ENVIROCARE OF UTAH, INC.
THE SAFE ALTERNATIVE

March 6, 2000

Overview

- Follow-up of NRC 8/16/99 NOV
- Other outstanding groundwater violations
- Results of soil sampling
- Discussion of Proposed Monitoring Plan

11e.(2) - Selection of Metals Compliance Parameters

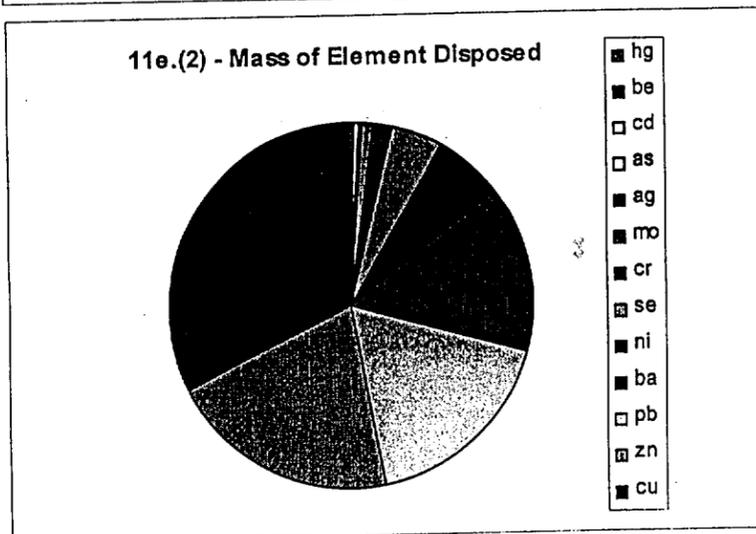
- Approach appears to be acceptable, but Kd values are an unknown. May have to either do a literature study on the affects of high TDS on Kd or conduct site specific Kd studies. Concern is that the Kd values proposed may vary by several orders of magnitude.

- Conduct literature search to do a qualitative evaluation as to the affects of high TDS waters on Kd.
- Prepare final report on hanging the monitoring network to include the following:
 - Use only Lead, Copper, and Zinc as compliance parameters
 - Continue to use Uranium, Thorium, and Radium as compliance parameters
 - Sample for Volatiles and Semi-volatiles on an annual basis
- Conduct lab study to do a quantitative evaluation as to the affects of high TDS waters on Kd.
